PLANNING COMMISSION REGULAR MEETING AGENDA

Wednesday, May 27, 2026
7 p.m.

5. **P26-0360 and PUD-152, 231 Old Bernal Avenue**- Applications for: (1) Planned Unit Development (PUD) Rezoning (P26-0360) to rezone the subject parcel from MU-T (Mixed Use-Transitional) District to PUD-MU-T (Planned Unit Development-Mixed Use-Transitional) District; (2) Certificate of Appropriateness to demolish an existing 6,160-square-foot commercial office building in the Downtown Revitalization District; and (3) PUD Development Plan (PUD-152) to construct a three-story, four-unit residential building on a 0.49-acre lot, with units ranging in size from 430 square feet to 13,626 square feet and associated site improvements located at 231 Old Bernal Avenue (APN: 94-156-21). The project is exempt from the California Environmental Quality Act (CEQA) pursuant to Public Resources Code Section 21080(b)(5) and CEQA Guidelines Section 15270, which statutorily exempt projects that a public agency intends to deny.

Figure 4: Inconsistent location of Refuse Area Bins

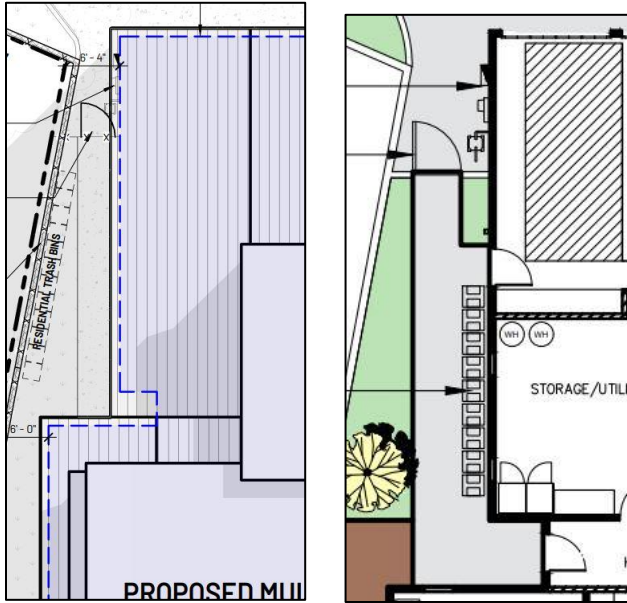
In addition, per ODS B9.1, exterior refuse areas are required to be located outside of a 50-foot radius centered on the primary building entrance and shall be screened by opaque, roofed enclosures built of durable materials and designed to harmonize with the proposed architecture. The project proposes locating the refuse area within a 50-foot radius of the primary building entrance. The refuse area will consist of 12 bins, as required by Pleasanton Garbage Service (bins for regular waste, recyclables, and green waste for each unit). Plans show an inconsistent location, but in either layout are within a 50-foot radius of the entry and would not conform to this standard (Figure 4).

PROPOSED SITE PLAN	SCALE:
	1" = 10'-0"

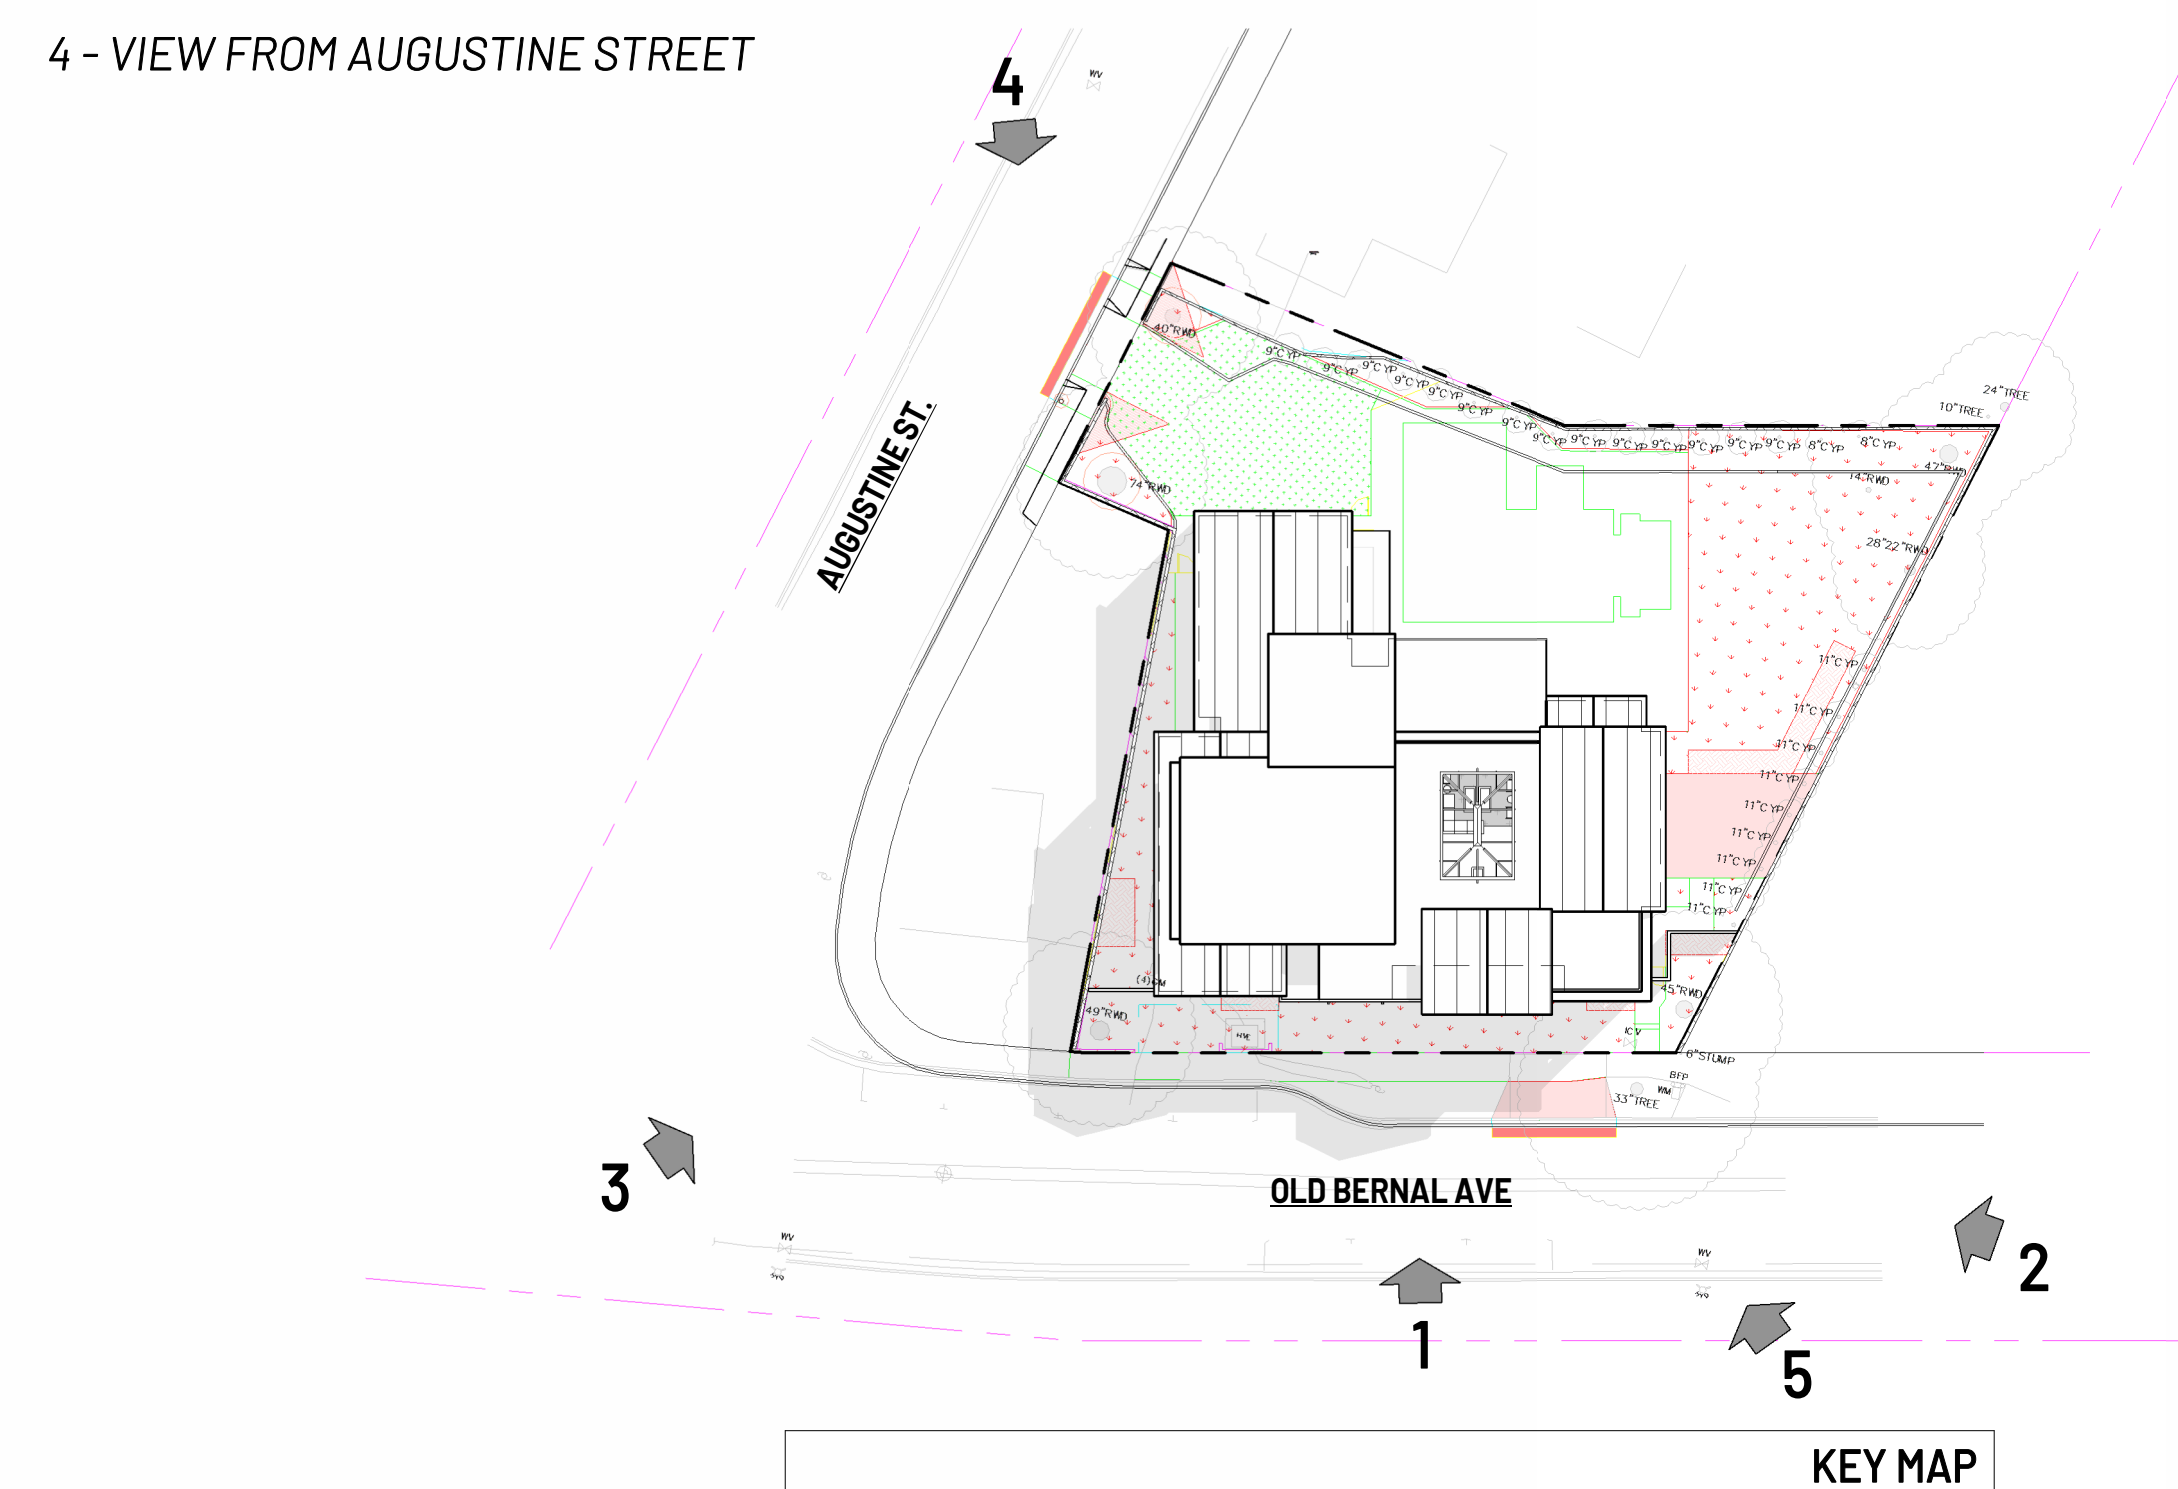
Per Table 1 above, the project is proposing a nonconforming nine-foot front setback and a six-foot side setback from the west property line. Further, per ODS C1.3, no structure abutting existing residential development shall exceed the height of a sloping plane 15 feet in height at the interior of the minimum required side yard required by the PMC and sloping away from the side property line five feet for each additional 15 feet in height. ODS C1.3 defers to the PMC for the District's minimum side yard, which is 10 feet. Also, per ODS C1.3, the project's west side property line setback requirement is 15 feet. Based on the project's proposed height, the west side setback is nonconforming by nine feet (see sheet A100 in Exhibit B).

- b) Sheet A001:
 - i. Revise "Proposed Yard" for "Rear" from 10' to 37'-6".
 - ii. Revise "Maximum Height Limit" from 3 stories to 2 stories.
- c) Sheet A100: Annotate how many bike parking spaces are provided in the shown bicycle parking illustration. For example, "Bicycle Parking (4 stalls, 8 spaces)".

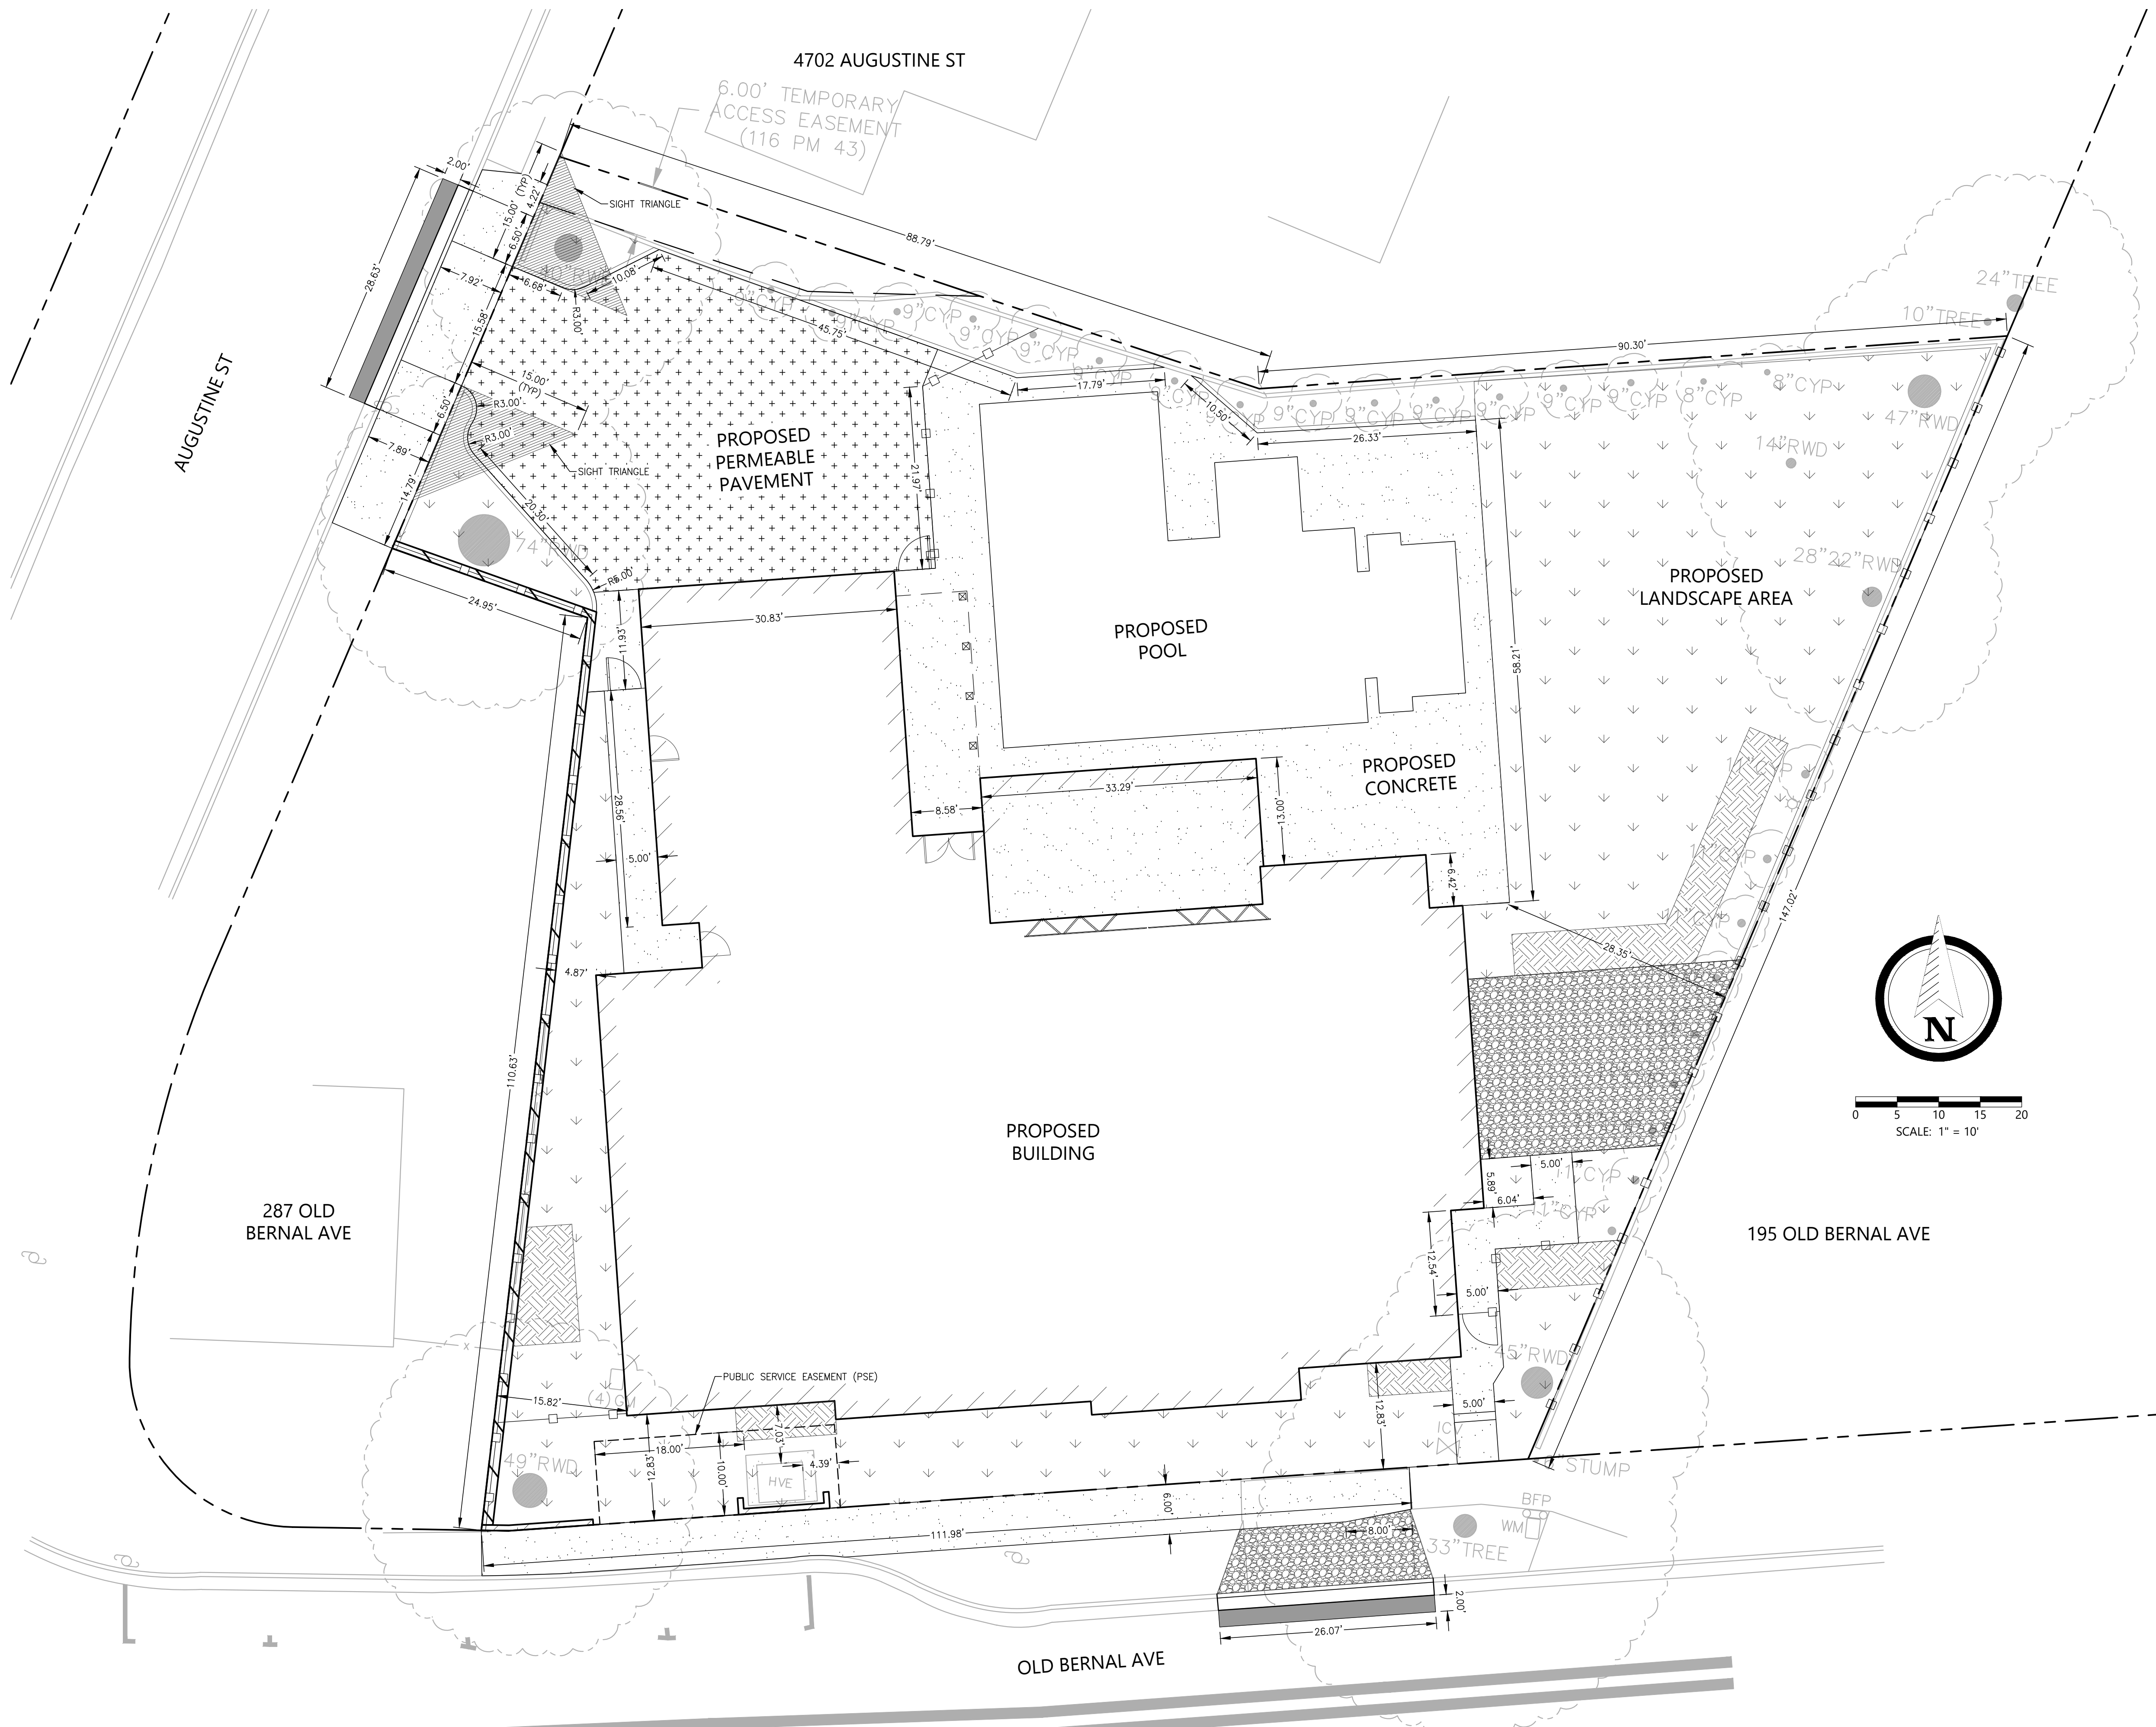
As referenced, during the August 2025 Planning Commission workshop, there was public and Planning Commission interest in maintaining the existing redwoods on-site. However, trees #31 and 32 are located within the traffic sight distance triangle; while recognizing there may be value in retaining these trees due to their size and character, Traffic Engineering staff notes that removing them would improve visibility for vehicles exiting the site and meet City guidelines for safety (see Sheet C3.0 of Exhibit B).

14. SAME COMMENT FROM PREVIOUS SUBMITTALS: The sight distance triangles on sheet C3.0 show obstructions within the triangles and do not meet city guidelines for safety. In addition to the redwood on the north side that falls within the triangle, the proposed 6' fence, shown on sheet A100, does not comply with city sight distance triangles and shall be removed.
15. The sidewalk on Old Bernal Ave shall be a minimum of 6' wide along the entirety of the project frontage.
